Wheaton Grandview Sketch Plan No. 320150070

RE: Sketch Plan No. 320150070
Wheaton Grandview

Re: DRC Comments and Point by Point Responses for Wheaton Grandview – Sketch Plan
No. 320150070

Figure 13 - The new Business District Street B-19

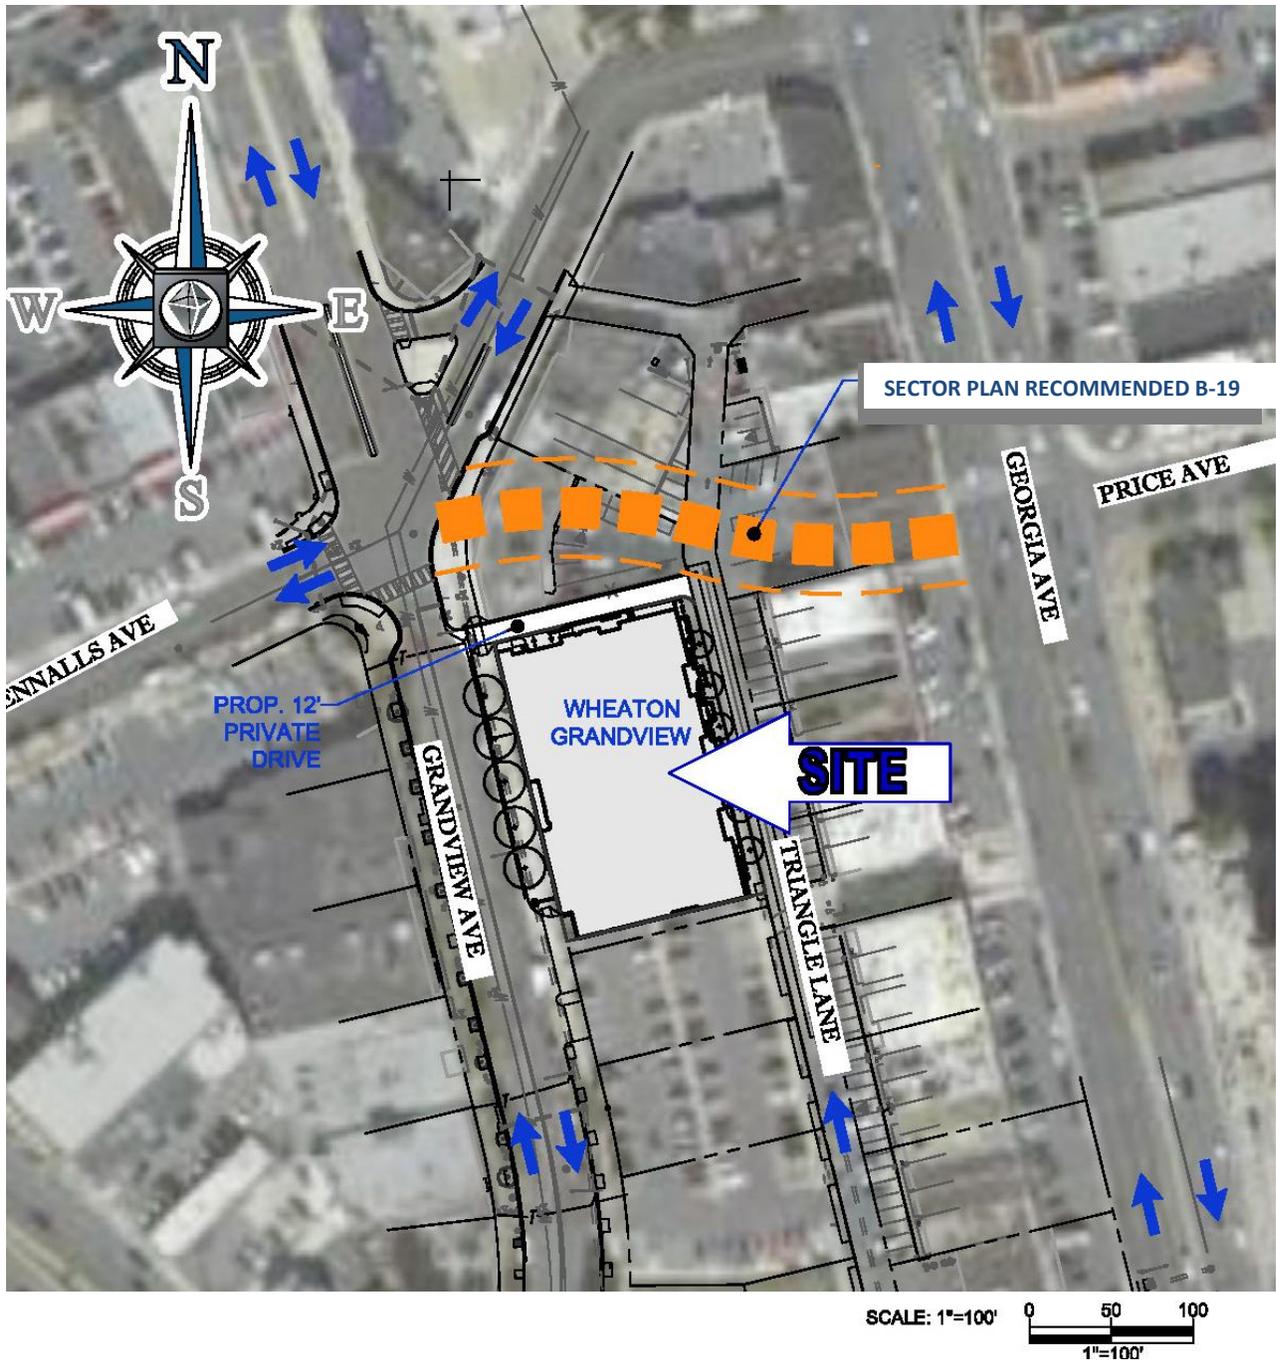
Comment 1: Clarify relationship of proposal's north façade to the future extension to Ennalls Avenue (proposed business street B-19 in the Plan's road classification table)

Comment 4: Show on the plans how the Sector Plan business street, B-19, would impact the northeast corner of the site - with its Sector Plan alignment crossing diagonally between Grandview Avenue and Triangle Lane

Response: **As reflected in the graphic entitled "Existing/Future (Sector Plan Recommended) Ennalls Avenue – New Street B-19", enclosed with this resubmission, the construction of new Street B-19 connecting Ennalls Avenue to Price Avenue, as recommended in the Wheaton CBD and Vicinity Sector Plan, will not be located on the Subject Property. Rather, in connecting the existing terminus of Ennalls**

Response: **See responses above to Comment 1 from Area Team 2 on Sector Plan above as to new Street B-19.**
